**DEVELOPMENT REVIEW COMMITTEE
STAFF REPORT
DECEMBER 12, 2023**

Application Number: 22PLN-37
Subject: Development Review Permit for the construction of a three-story, ±42,000 square foot/80 room Holiday Inn Express on a 2.74 acre portion of an 11.83 acre parcel
Location/APN: 961 Plaza Drive/035-480-039
Owner: Rajinder Singh, Grass Valley Hospitality, Inc.
Applicant: Jeff Morrish, NST Engineering, Inc.
Zoning/General Plan: Central Business (C-2) Zone/Commercial
Entitlements: Development Review Permit

REAR ELEVATION - East
SCALE 1/8" = 1'-0"

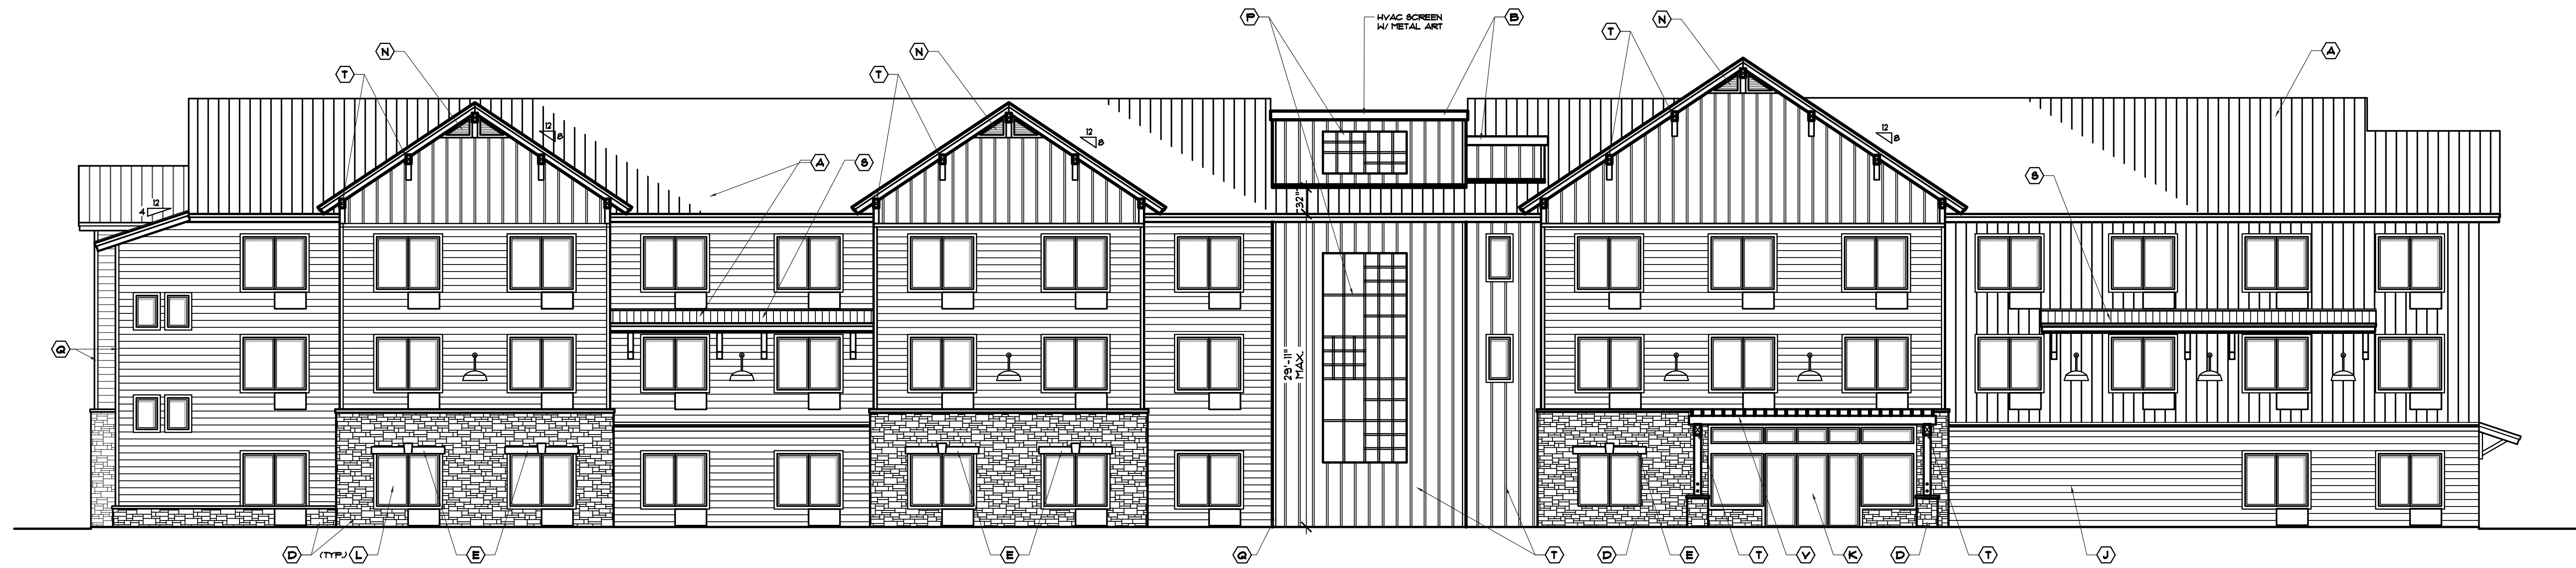
1. The stamped concrete in the porte cochere and rear patio will be tan.
2. The metal art on the rear exterior elevation will be constructed of tubular steel and will be colored black. The art is transparent and will be attached to the wall. The wall color behind the art will be exposed. The art piece will be connected to the wall in such a way that it will set away from the wall plane so that a shadow affect will be created.

FENCE ALONG PROPERTY LINE (1) C2.2

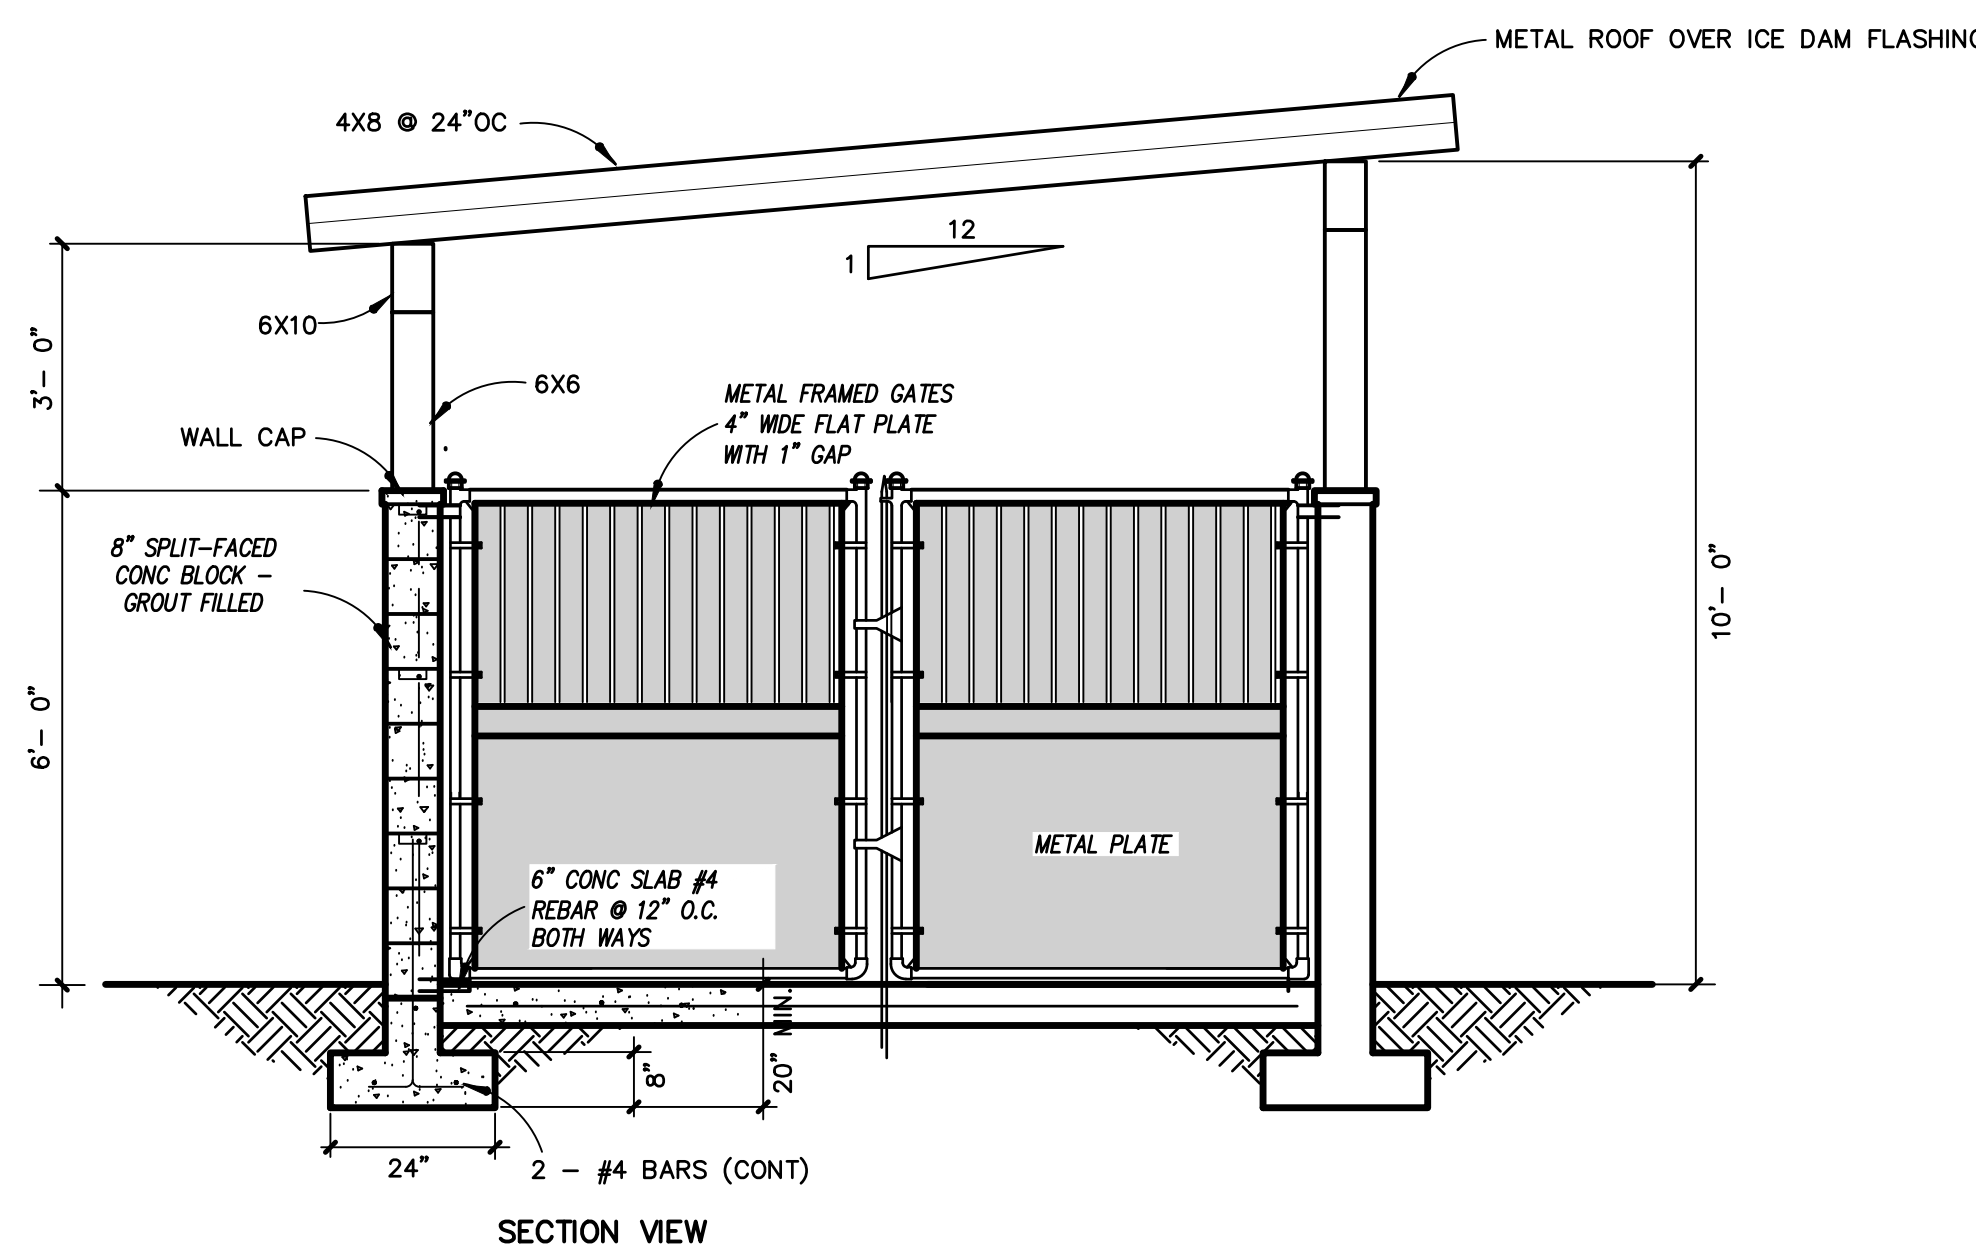
Residential Screening – Section 7.30.040 (F.1.a) of the municipal code requires screening between commercial and single-family residential land uses in the form of a 6-foot high solid, masonry wall. The applicant is requesting that the city consider allowing the proposed metal fence due to the topography of the adjacent residential use and building pads located nearly 15 feet above the adjoining property line, with further consideration of the 4 to 6 foot retaining wall that will be located along this property line. The applicant has provided the following justification:

The rear property that adjoins the residential land uses is shown on Sections 1, 2, and 3, on Sheet C2.2. Section 1 is actually found along the adjacent commercial land use section of the property. A metal fence along the property line seems more attractive and allows view of the natural open space to extend into the adjacent parcel. Sections 2 and 3 show the fill slopes on the adjacent residential property as well as the cut slope and retaining wall at the hotel site. The future residential building pads are going to be 20 to 25 feet above the finish floor of the hotel and the property line elevations is almost 15 ft below the residential building pads. A 6 ft masonry fence at the property line will not provide any sound barrier or affect the sight lines from the view of residences towards the hotel. Also, a higher masonry fence will seem to loom over any hotel guest use of the rear yard. Therefore, a metal fence seems to be a better solution. Once the landscaping of the residence and the hotel are complete this landscaping will create a much better sound barrier and visual buffer.

LIGHTING PLAN

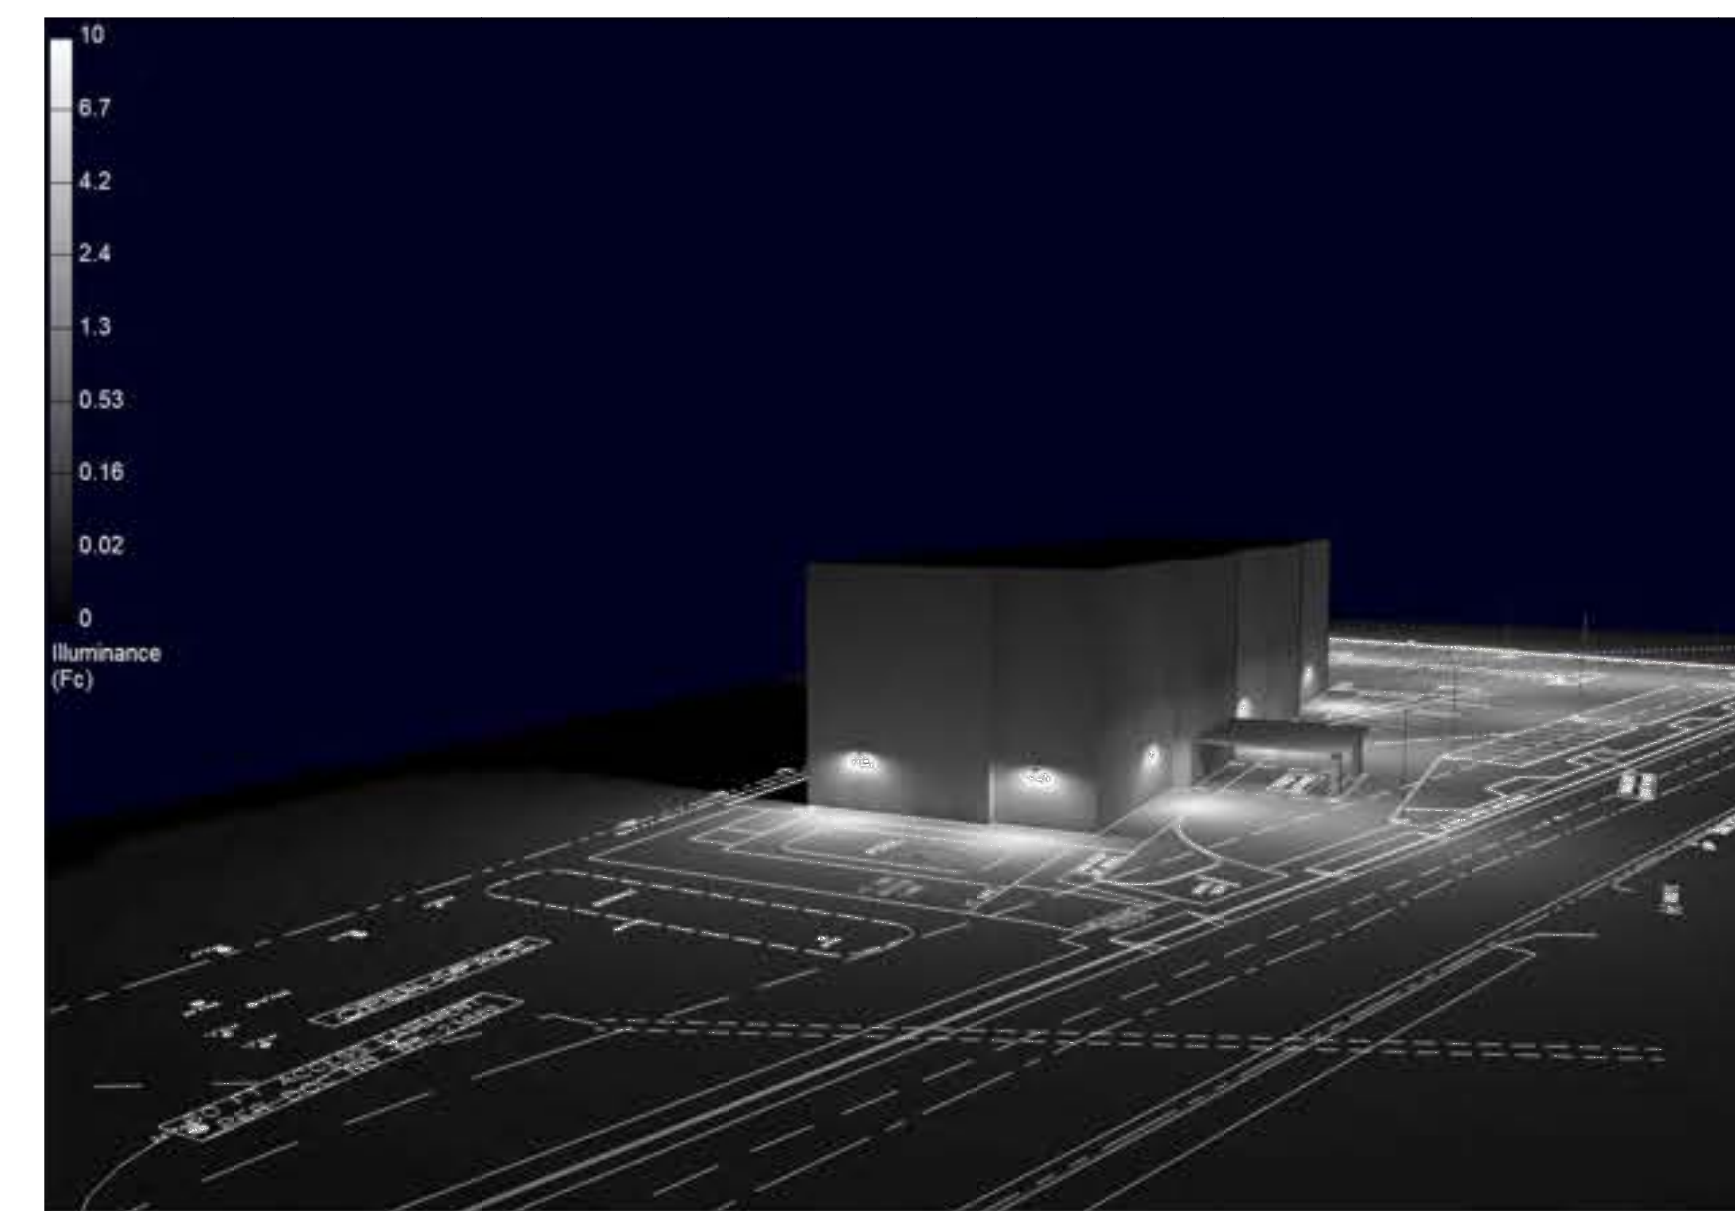
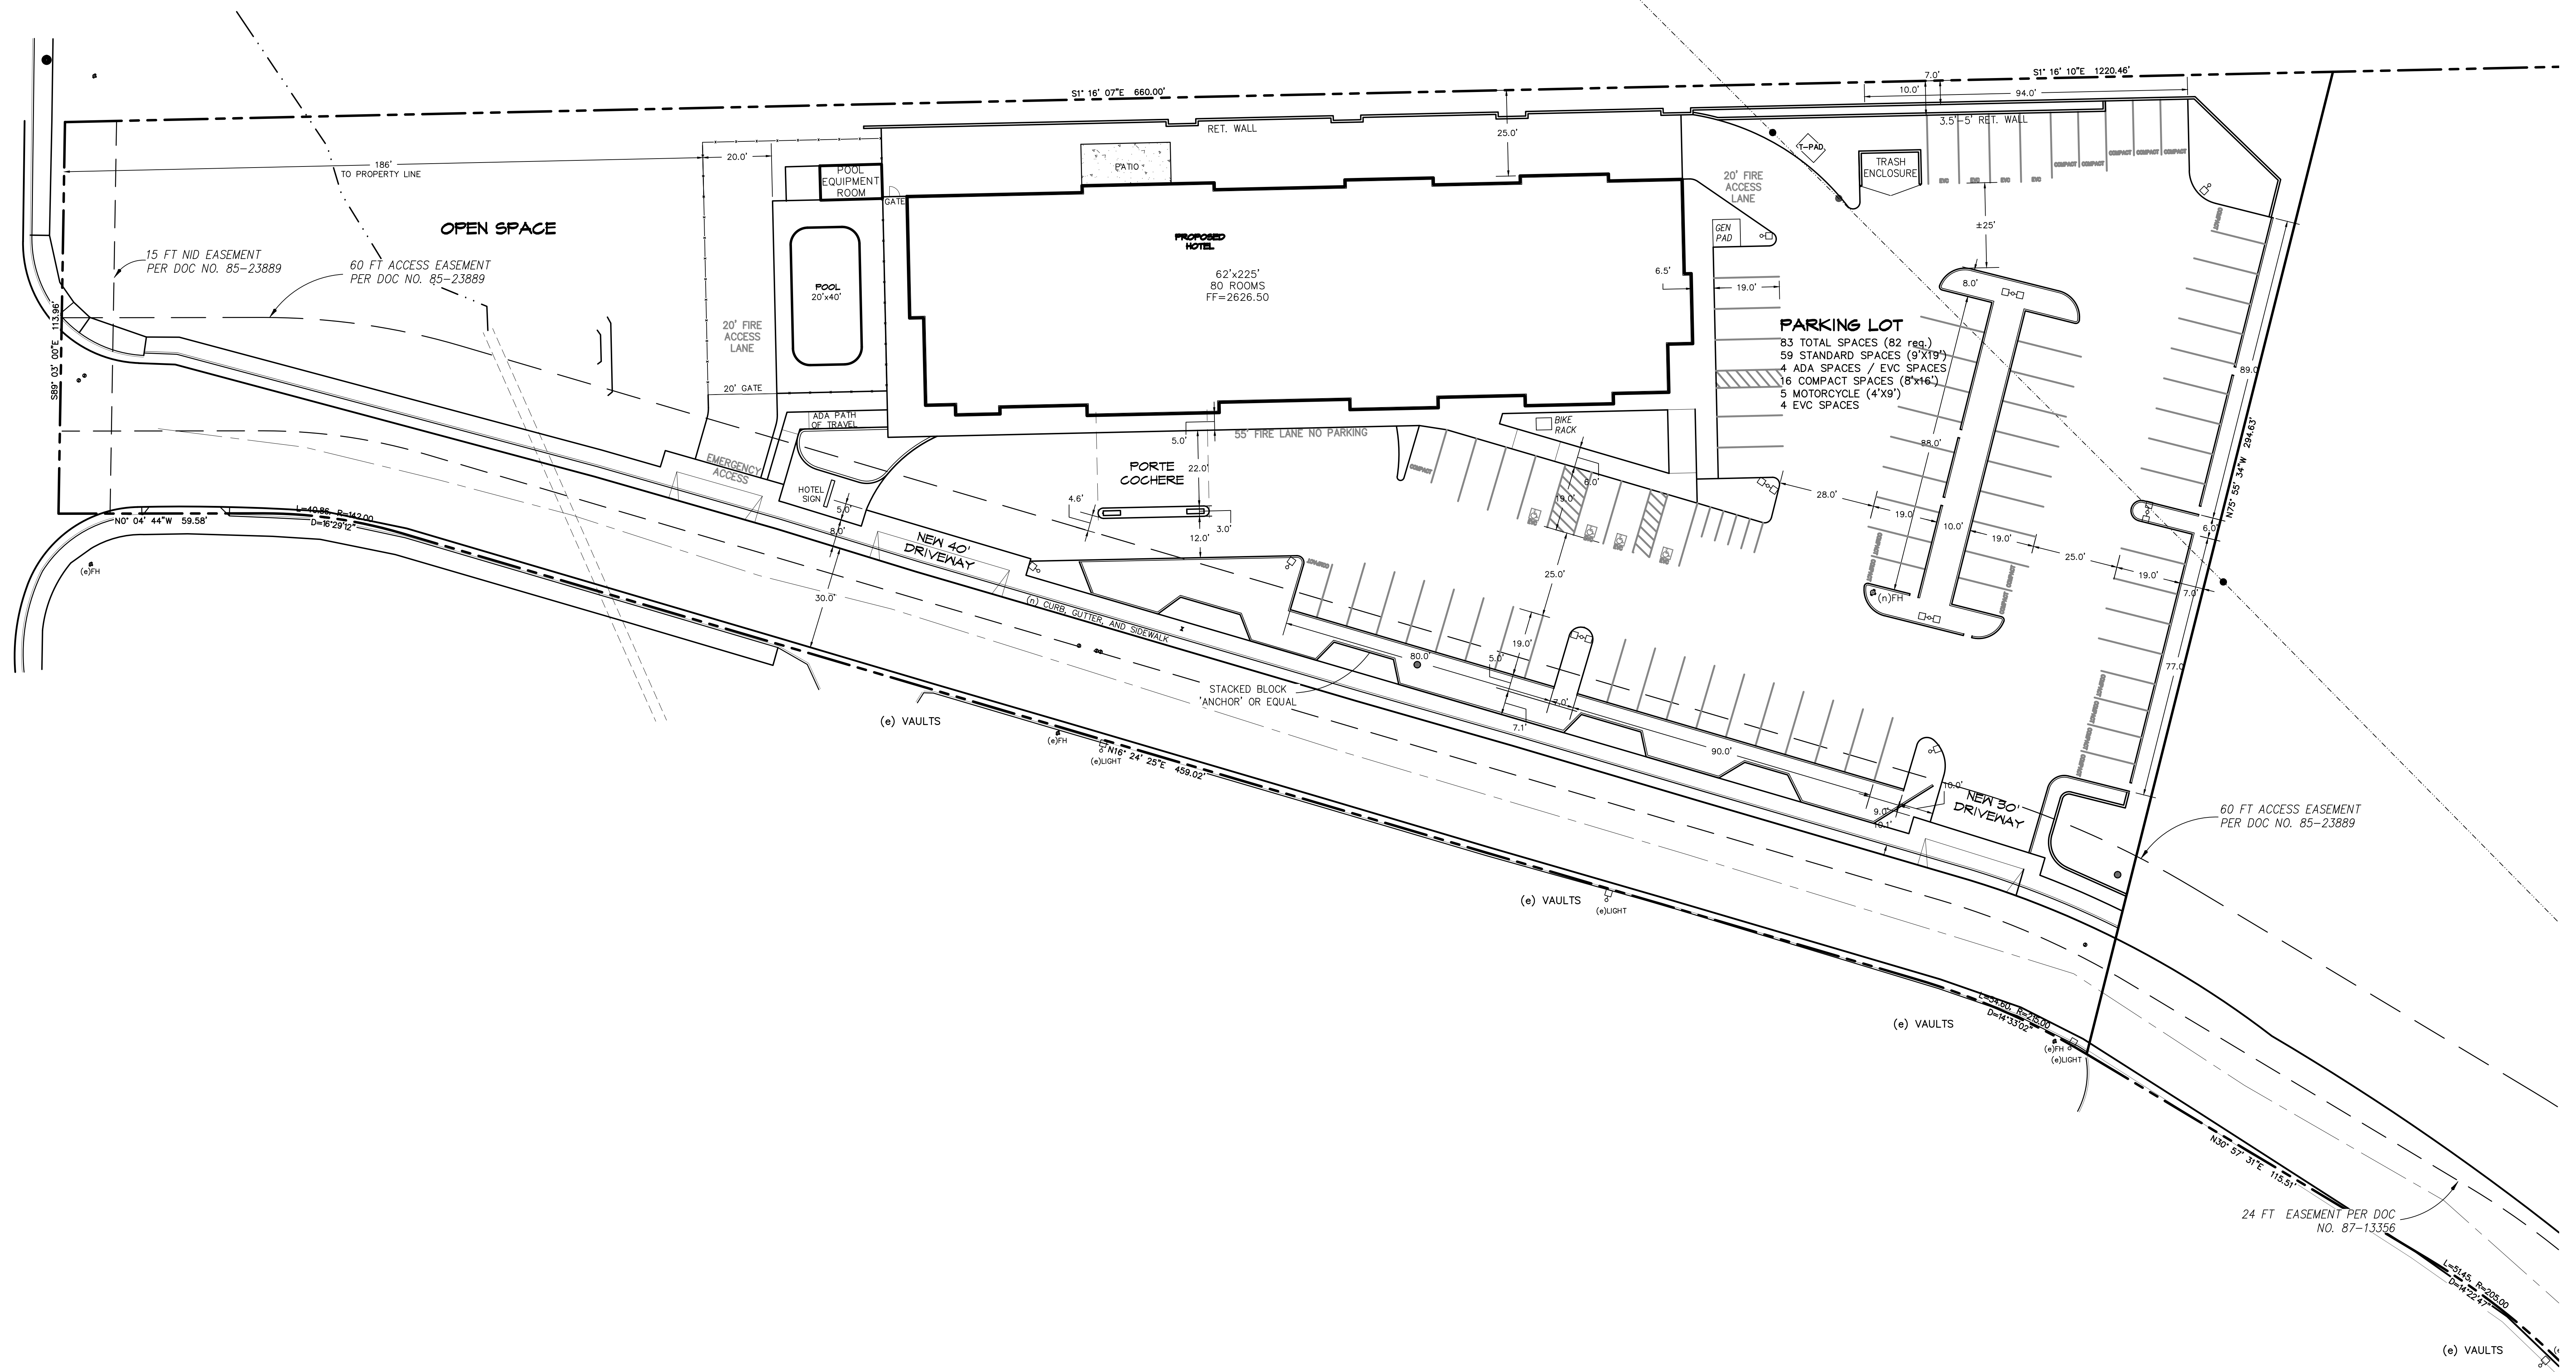
Lighting - Lighting proposed for the project site includes 20-foot parking lot pole lighting, and gooseneck wall fixtures on the building. Section 17.30.060 of the City Municipal Code provides standards for outdoor lighting. Subsection A states that a fixture shall not exceed eight feet where adjacent to a residential area, though the development review committee can allow fixtures to reach up to twenty feet in height where it determines the additional height will comply with all other

Section 5.2 (b) states that parking and vehicle circulation area light standards should not exceed twelve (12) feet in height. We have proposed a twenty (20) foot high light standard in order to minimize the number of light fixtures and maximize the number of trees in the parking lot. The cut-off ‘down’ light standards will reduce light spillage and glare in adjacent properties as shown on Sheets C5 and C5.1 (under 0.5 footcandles at property line). The taller light standards in the parking lot allows for a better light pattern across the aisle and parking spaces than a lower, higher intensity light. As noted before, there will be a reduced number of light standards, especially after the trees start to grow and increase in height. The pedestrian walkway lighting will be provided from wall mounted ‘down’ lighting and should give adequate lighting and splash the exterior walls for aesthetic purposes. Any free standing light fixtures along the pedestrian walks will be less than eight (8) feet high.
